3 **REVISED PER ADDENDUM No. 3 DATED NOVEMBER 9, 2015**

BRIDGE NO. 53-1471
POST MILE 0.86

VINCENT THOMAS BRIDGE RETROFIT
GENERAL NOTES

VINCENT THOMAS BRIDGE RETROFIT
SIDE SPAN TRUSS FUSE NO. 2

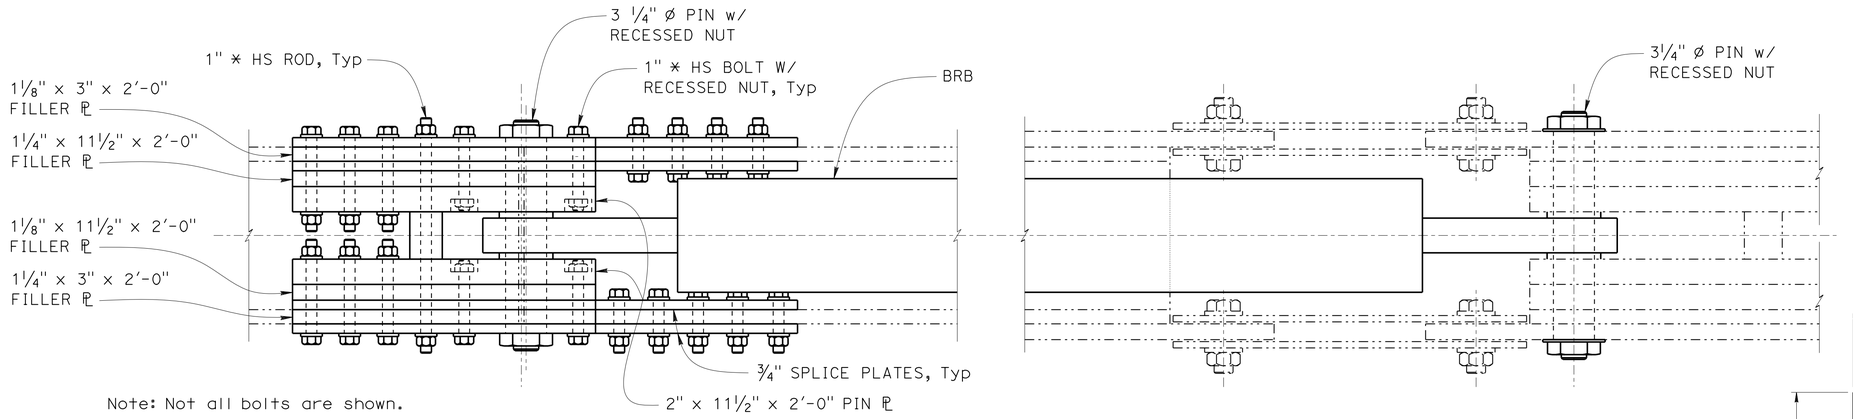
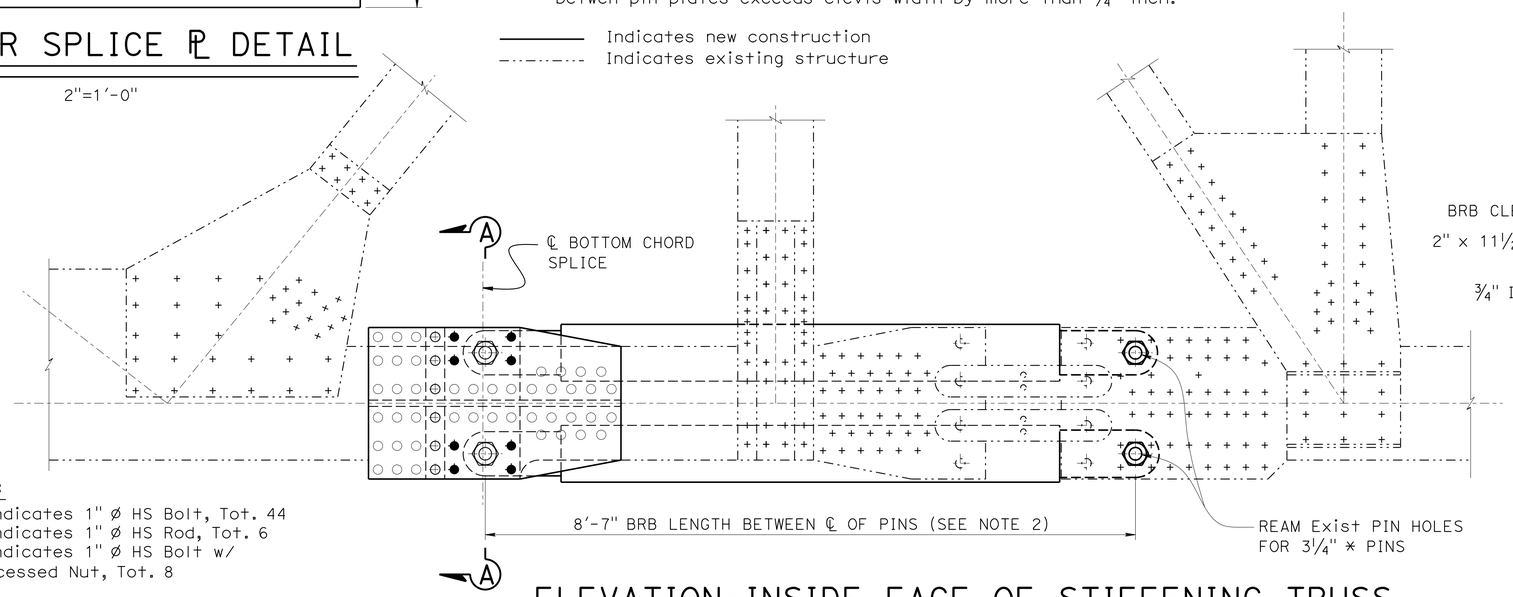
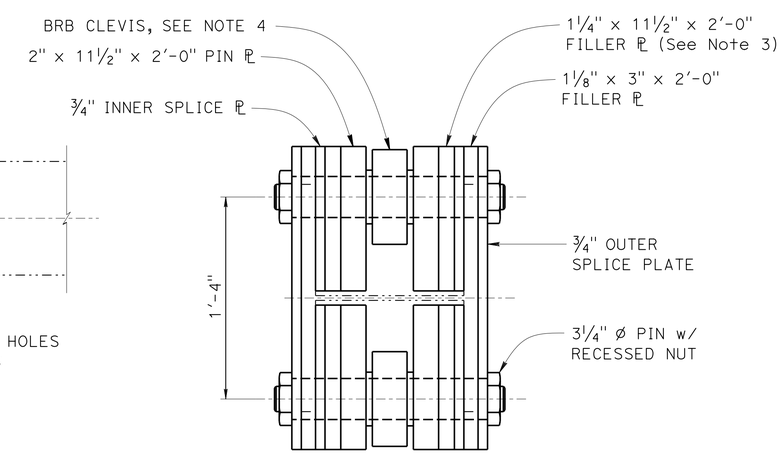
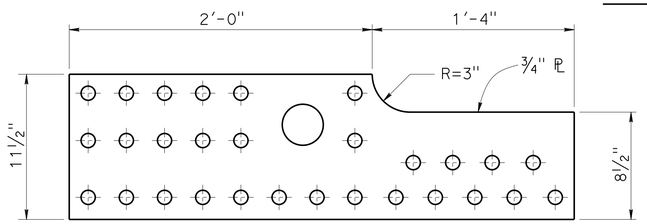
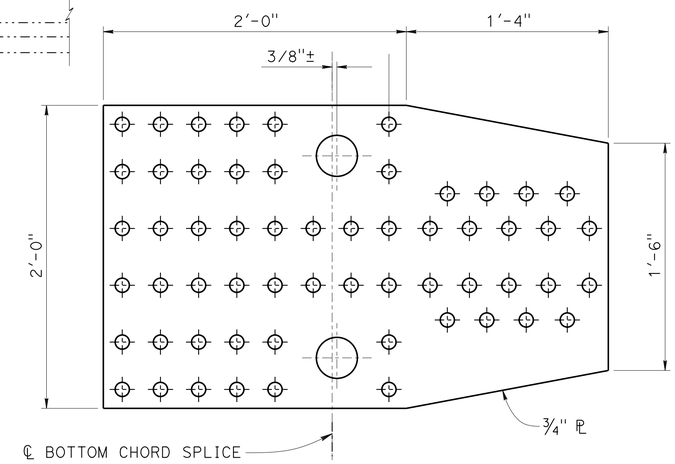
3

3 **REVISED PER ADDENDUM No. 3 DATED NOVEMBER 9, 2015**

VINCENT THOMAS BRIDGE RETROFIT
DAMPER/BRB DETAILS

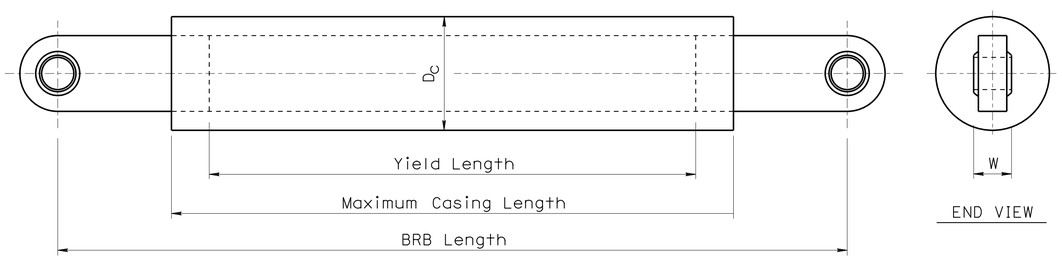
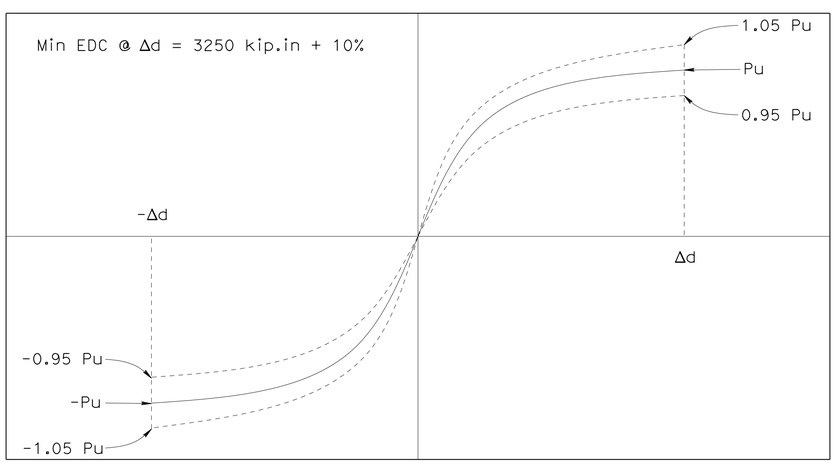
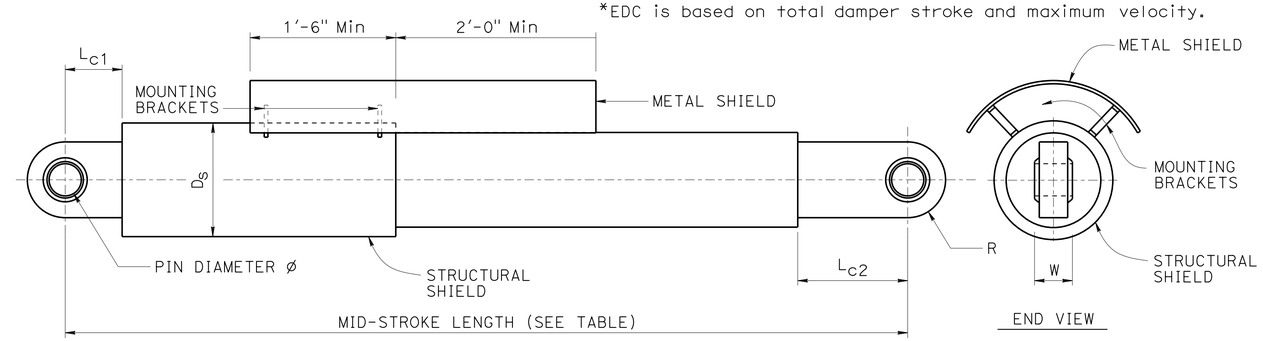
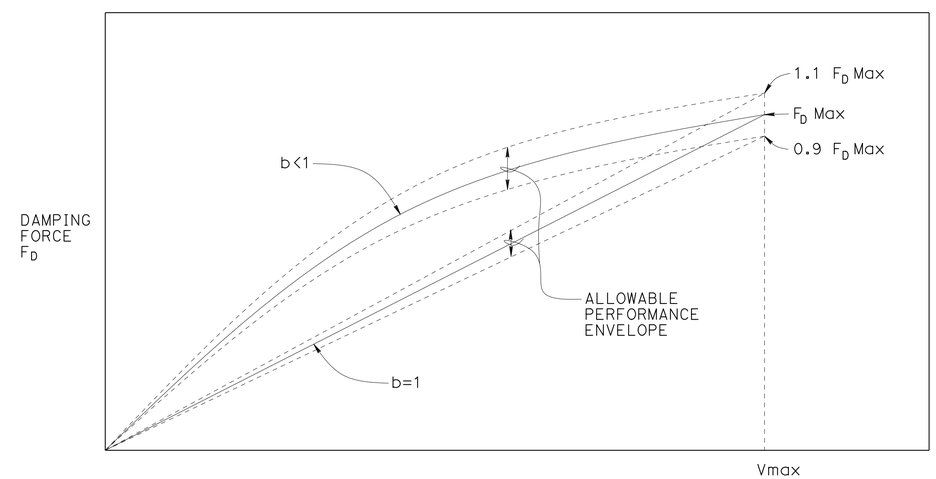
3 **REVISED PER ADDENDUM No. 3 DATED NOVEMBER 9, 2015** 3

VINCENT THOMAS BRIDGE RETROFIT
TRAVELER RAIL DETAILS NO. 2

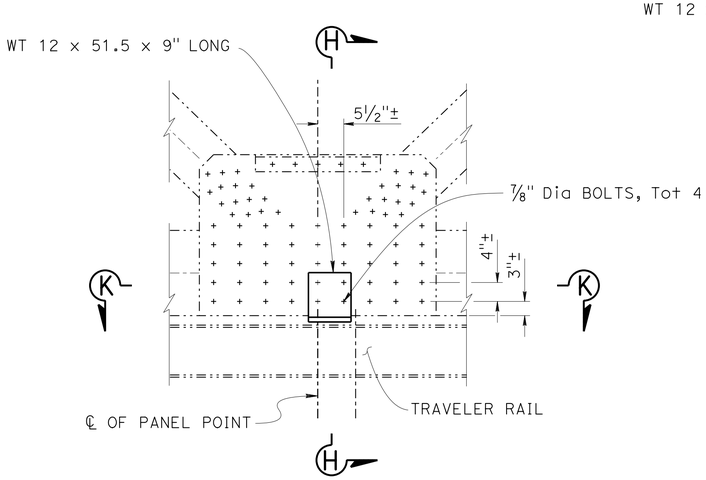
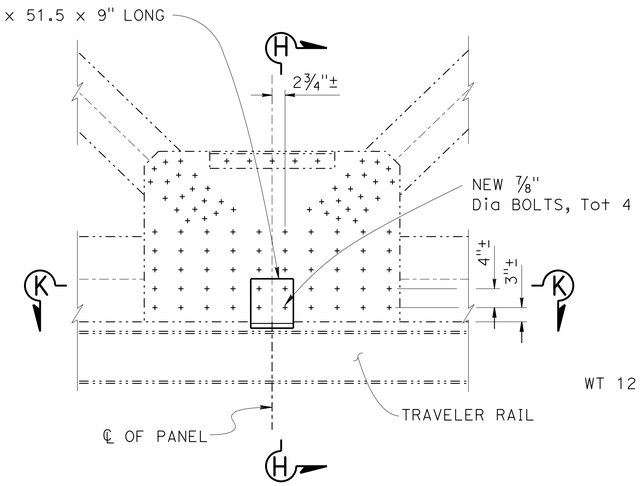
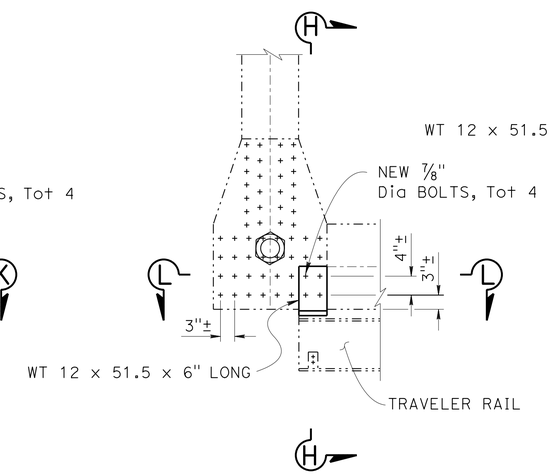
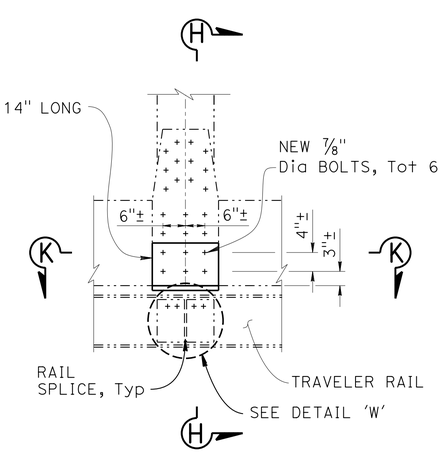
3 REVISED PER ADDENDUM No. 3 DATED NOVEMBER 9, 2015
